Addendum to Mitigated Negative Declaration

Addendum Date: **March 7, 2019**
Case No.: **2015-006224ENV**
Project Title: **Southeast Plant Headworks Replacement Project**
MND: **2015-006224ENV, adopted December 19, 2016**
Project Sponsor: **San Francisco Public Utilities Commission**
Lead Agency: **San Francisco Planning Department**
Staff Contact: **Julie Moore – (415) 575-8733**
Julie.Moore@sfgov.org

Figure 1: Headworks Replacement Project – Bruce Flynn Pump Station Sewer Connection

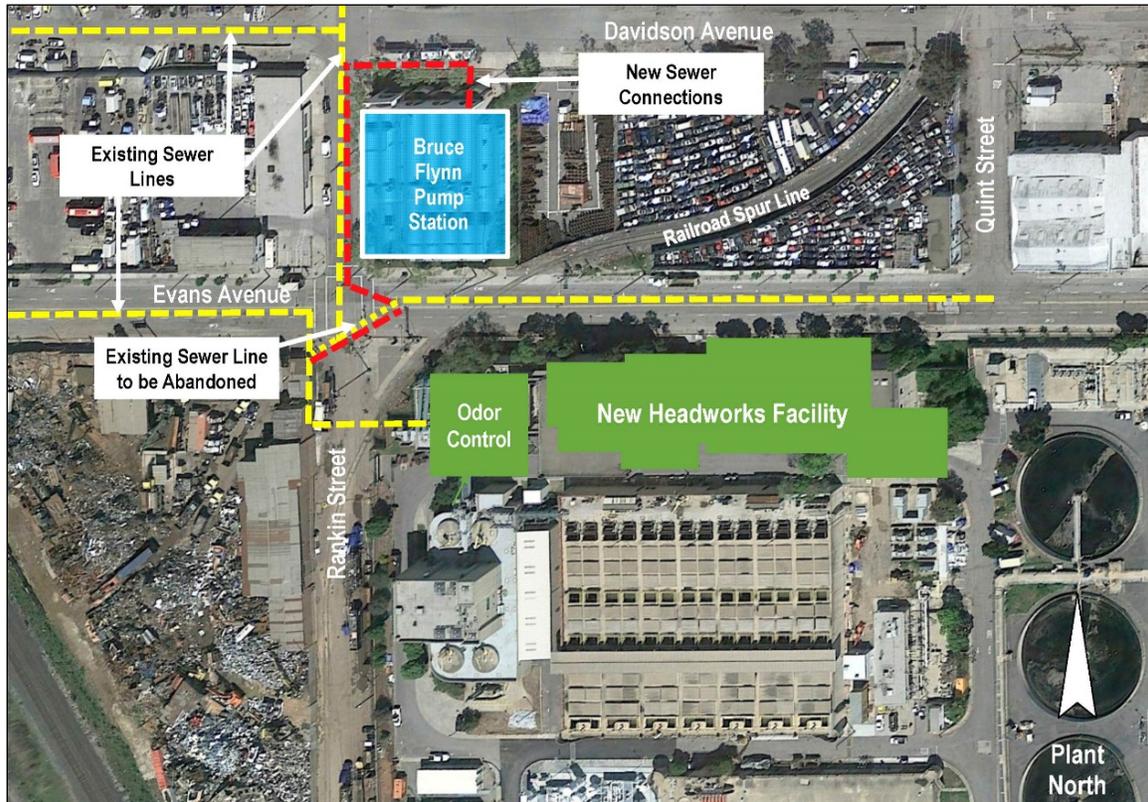
San Francisco Public Works is designing the upgrades to the Bruce Flynn pump station, which include modifications to the influent sewer. The 95 percent design was completed in September 2017. During design of the pump station upgrade it was discovered that the sewer connection from the pump station to Southeast Plant had major constructability issues, and hydraulic modeling showed that there could be operational problems with solids deposition during dry weather operations. In addition, it was determined that inclusion of a replacement lift station within the Southeast Plant could substantially increase operational flexibility and reliability.³ The public works design team evaluated options and determined that construction of a replacement lift station within the Southeast Plant would provide the best operational solution.⁴ The currently proposed solution would entail construction at an additional project location in the Southeast Plant, and construction of a large box sewer and pipelines in the plant between the new lift station and the new headworks, but would eliminate major sewer work on Davidson Avenue, Evans Avenue, and Rankin Street that was identified in the approved project. Locating a new lift station within the Southeast Plant would also avoid problems associated with constructing the previously-approved new pipeline between the new headworks odor control facility and the existing Bruce Flynn pump station (shown in red in Figure 1), which would have resulted in potential conflicts with other

utilities within the roadway and impacts on traffic within the affected roadways during construction.

This environmental review focuses on the proposed new lift station and pipeline connections from the new lift station to the odor control facility that will be constructed as part of the adopted Headworks Replacement Project. The proposed upgrade of the Bruce Flynn pump station that is included in the adopted Headworks Replacement Project would still occur, but internal improvements to the pump station would focus on enhancing reliability during wet weather events and the pipeline between the new headworks and the Bruce Flynn pump station in the adopted project would not be required.

Figure 2: Proposed Location of SEP 005 Southeast Lift Station

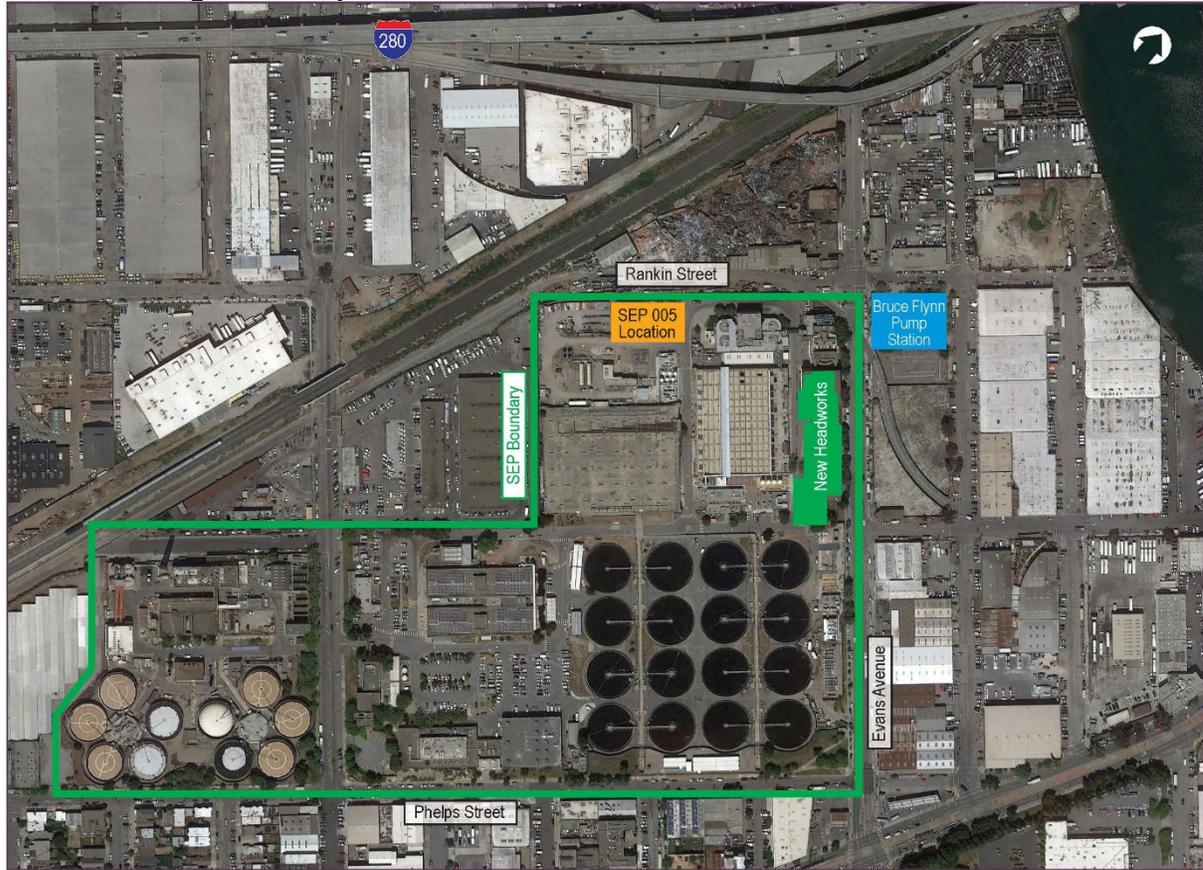
The SFPUC determined that there is sufficient space within the Southeast Plant between Rankin Street and the new liquid oxygen facility to construct a new lift station, as shown on Figure 2.⁵ The proposed new lift station is designated as SEP 005 – Southeast Lift Station.⁶

The SEP 005 – Southeast Lift Station would provide a firm capacity of 50 million gallons per day (MGD). The lift station would be about 115 feet long and 26 feet wide, and would be primarily below grade, with the deepest point being the wet well⁷ floor at 37 feet below grade. There would be three above-ground pump motors, two of which would extend about 18 feet above grade, with the third extending about 15 feet above grade.⁸

Figure 3: Site Plan for Proposed SEP 005 Lift Station and Associated Pipelines

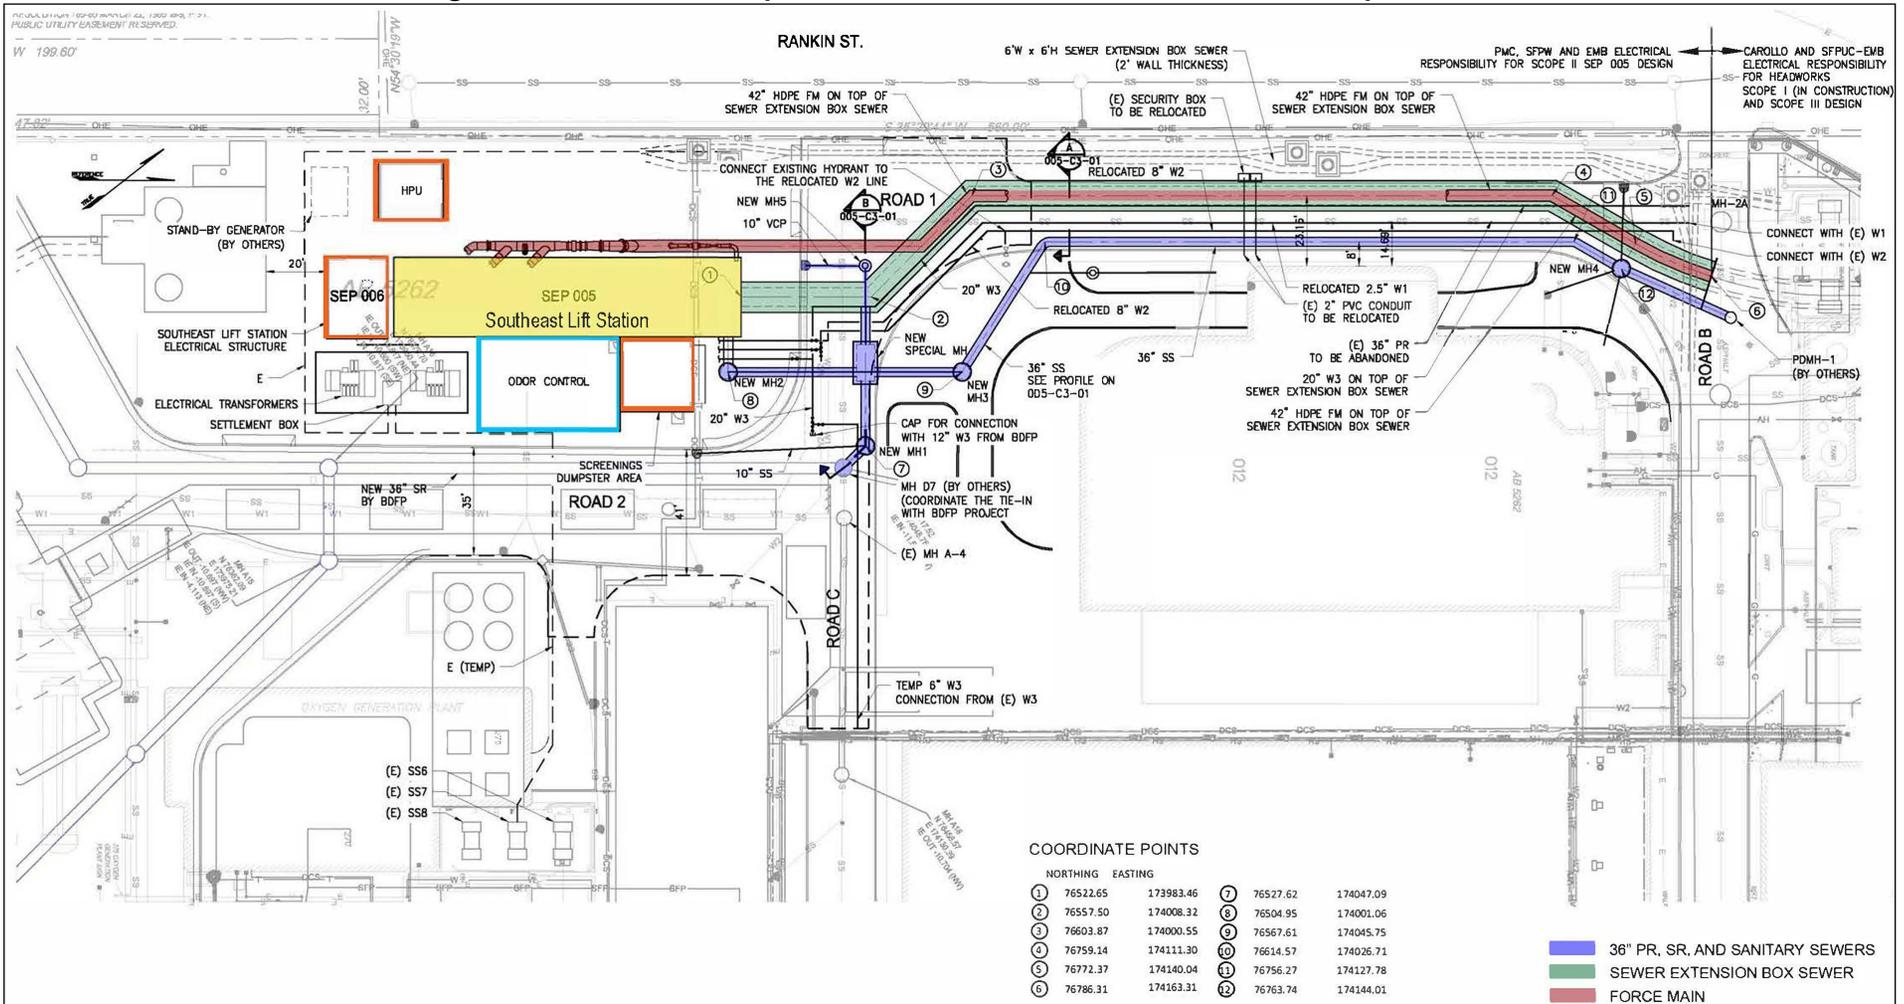
Figure 3 shows the site plan for the new SEP 005 – Southeast Lift Station. The major elements of the SEP 005 – Southeast Lift Station include the following:

- An SEP 005 – Southeast Lift Station (shown in yellow on Figure 3), which consists of a below-grade influent channel, mechanically-cleaned bar screens and screening handling equipment, and a trench-type wet well with three vertical turbine solids handling pumps with 450-horsepower motors;

- A new below-grade approximately 6-foot by 6-foot by 390-foot long sewer extension box sewer connecting the existing SEP 011 – Headworks south influent channel (leading to the existing Southeast Lift Station pumps) to the influent channel inside the proposed SEP 005 - Southeast Lift Station with two other pipelines to be constructed within the same trench:

- A new 42-inch force main discharging from SEP 005 – Southeast Lift Station into the SEP 020 influent junction structure;
 - 20-inch diameter pipeline conveying non-potable chlorinated effluent

- Odor control facilities (outlined in blue in Figure 3);
- New access gate;
- Electrical transformers; and

- Three facilities in above-ground single-story concrete masonry buildings with a steel roof (outlined in orange on Figure 3), located on the east side of Rankin Street, immediately west of the new Southeast Plant liquid oxygen facility:
 - Screenings handling and dumpster area (approximately 24 feet by 25 feet);
 - Electrical structure (SEP 006) (approximately 20 feet by 27 feet); and
 - Enclosed hydraulic power unit room (approximately 21 feet by 19 feet).
